Project Title: Refurbish Elevators and Replace Controls

Solicitation Questions and Answers
for
Refurbish Elevators and Replace Controls
Project: 437-22-101, RFP: 36C26324R0021
12/15/2024

Solicitation Questions and Answers (updated 3-26-2024) for
 Refurbish Elevators and Replace Controls
 Project: 437-22-101, RFP: 36C26324R0021

Drawing Number
A5.21

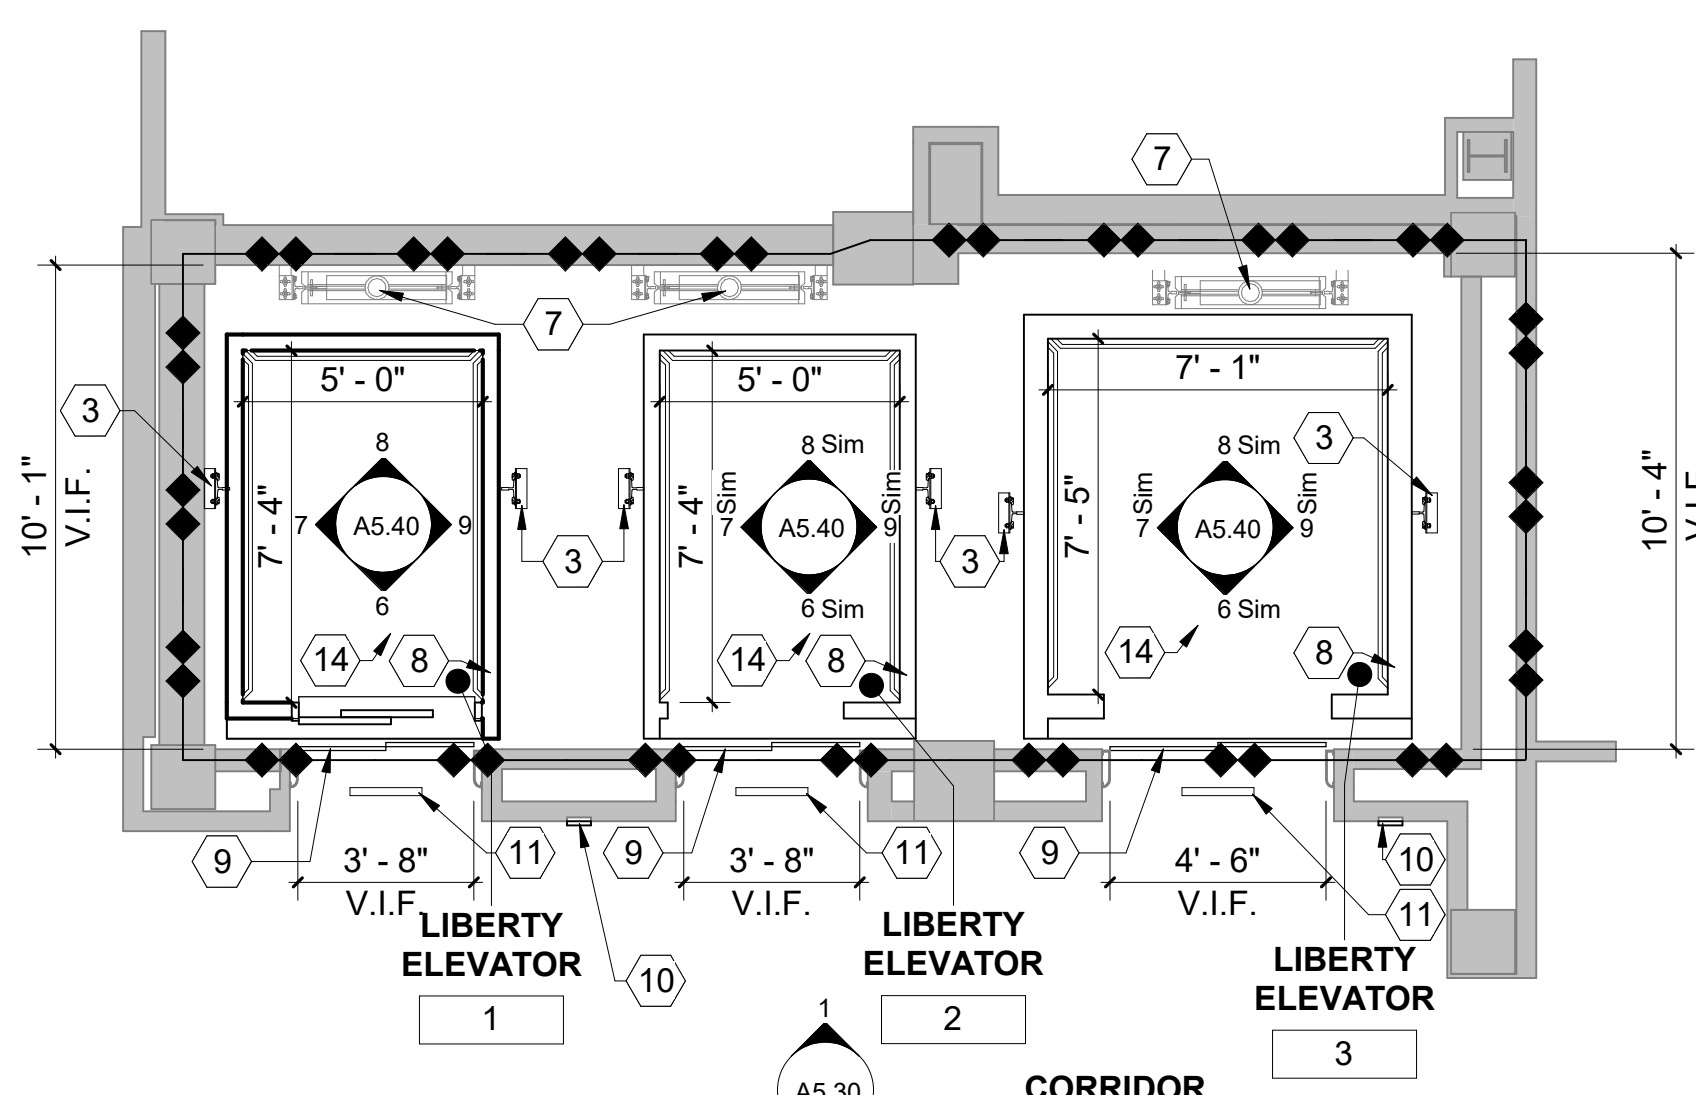
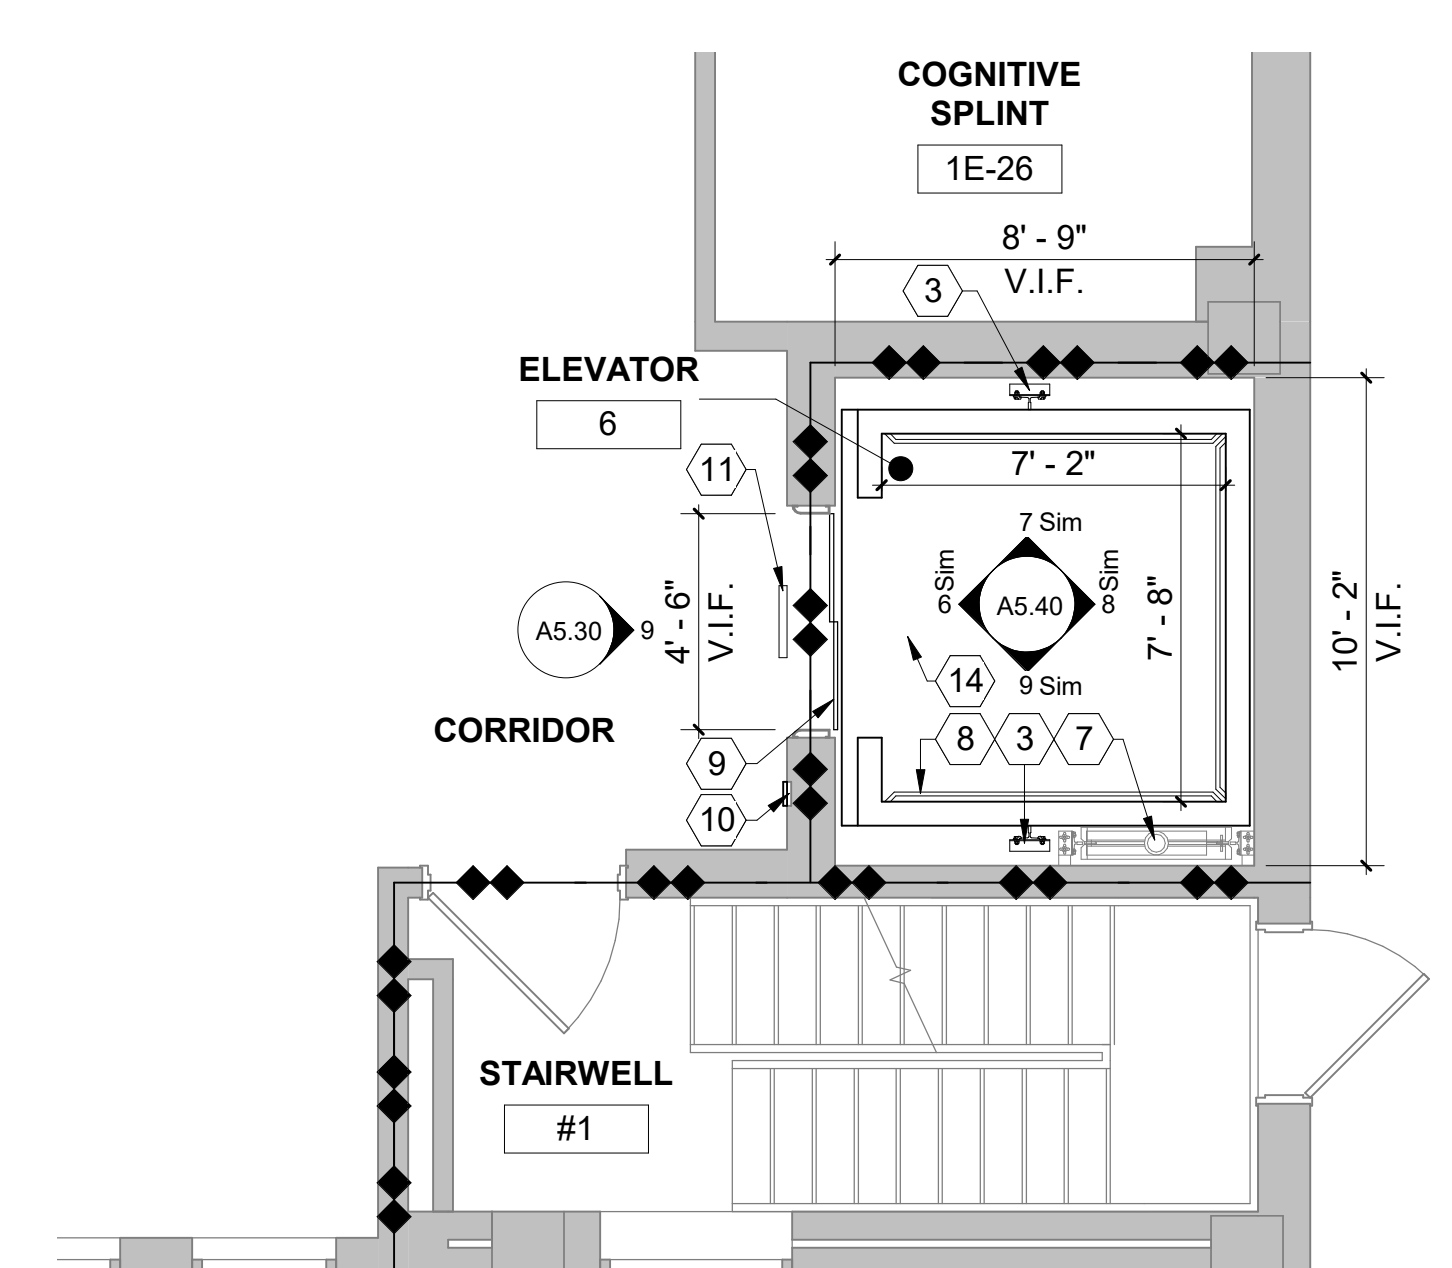
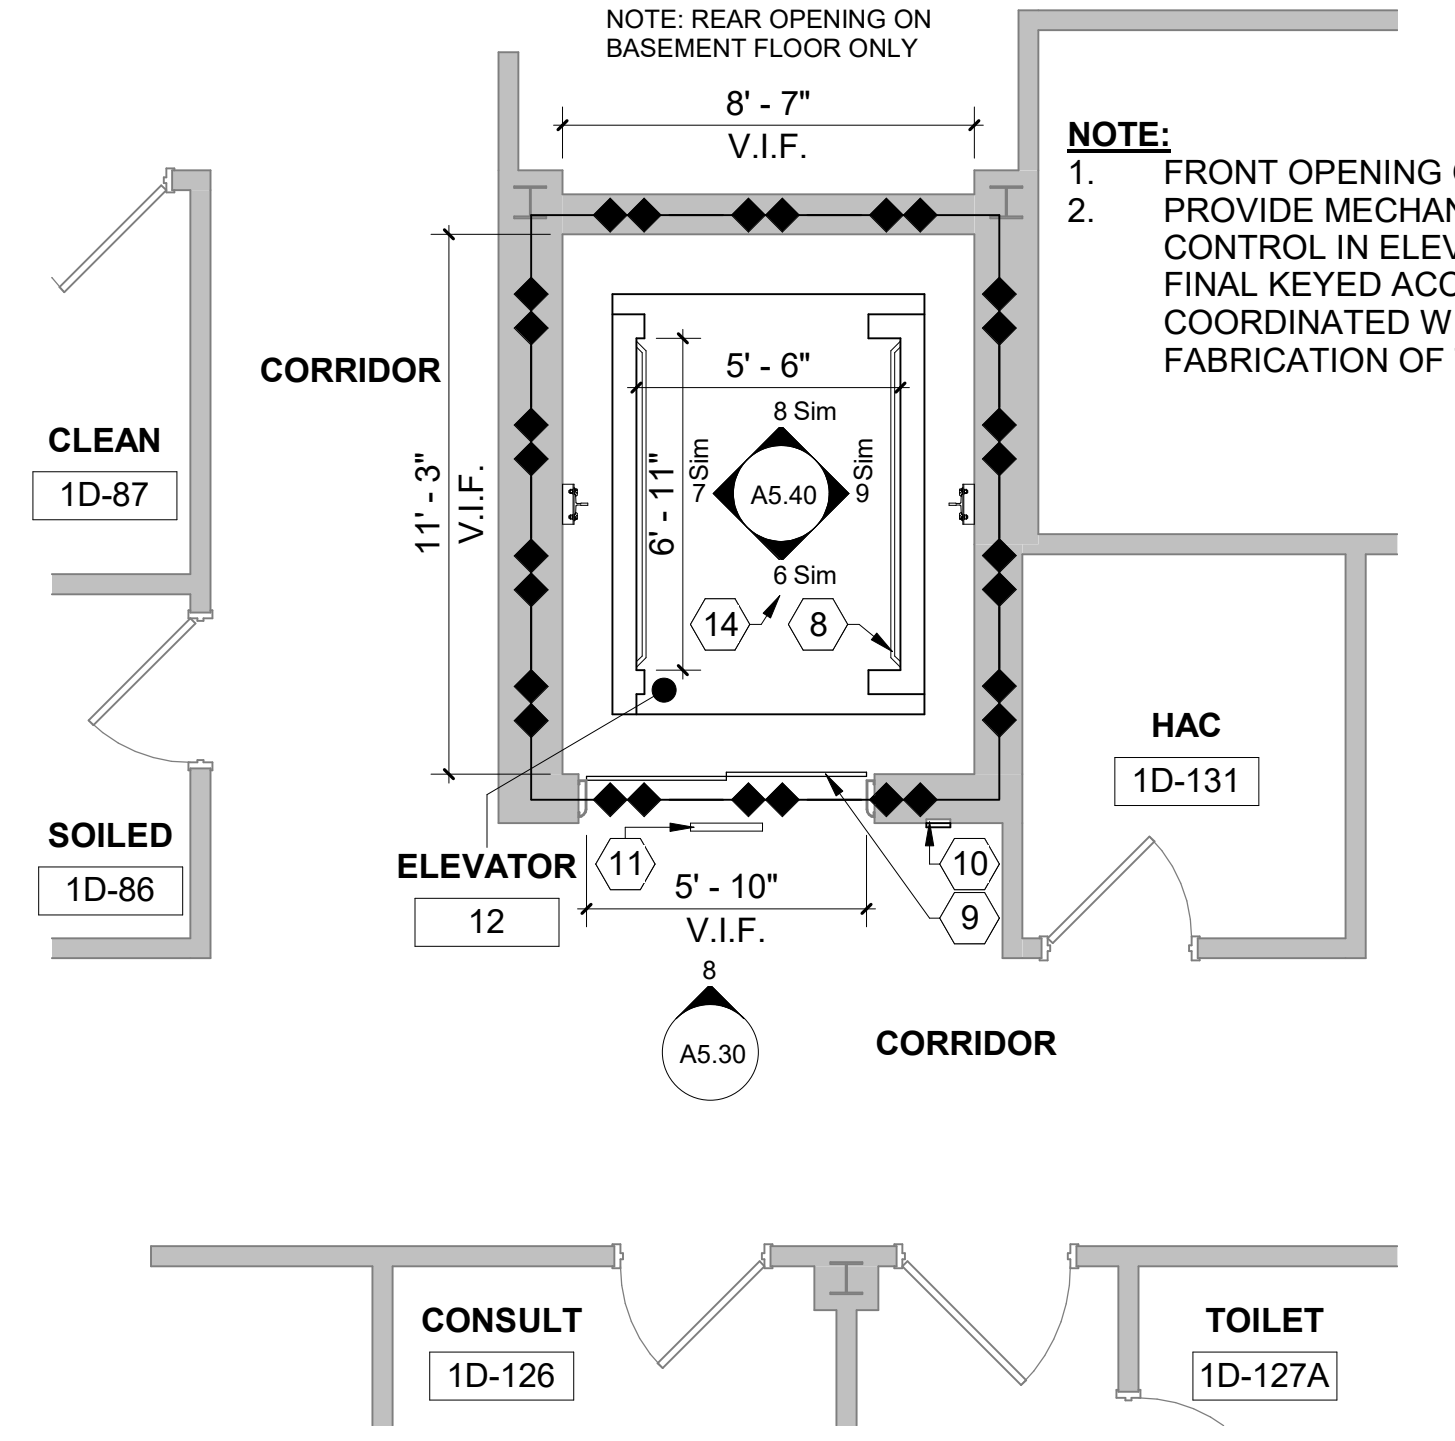
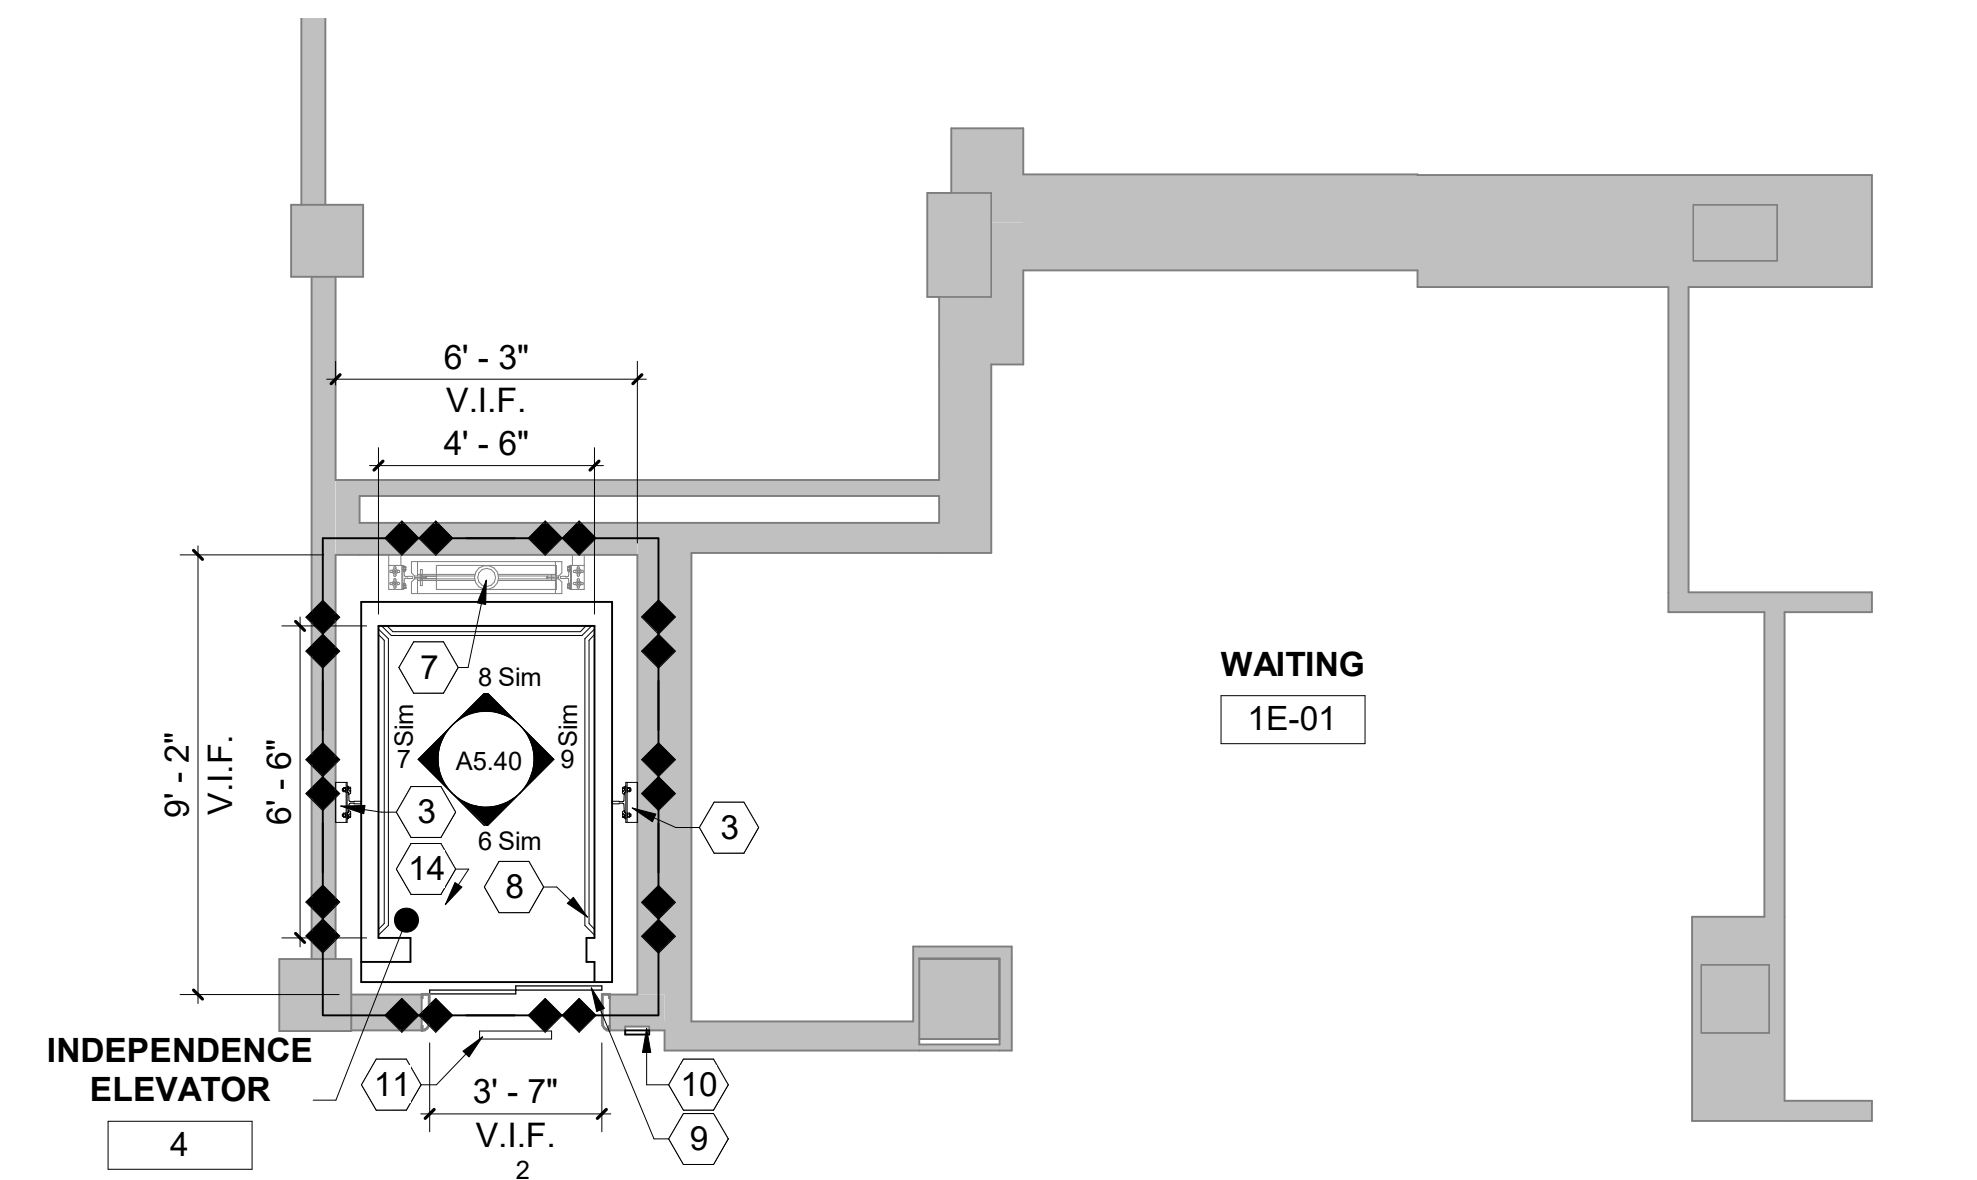
Drawing Sheet A5.21 ENLARGED PLANS – See revised drawing sheet for the inclusion of additional floor repair to support the installation of underfloor plumbing at Elevator #10.

Drawing Sheet A5.21 ENLARGED PLANS – See revised drawing sheet for the adjustment of keynotes # 3, 9, 15.
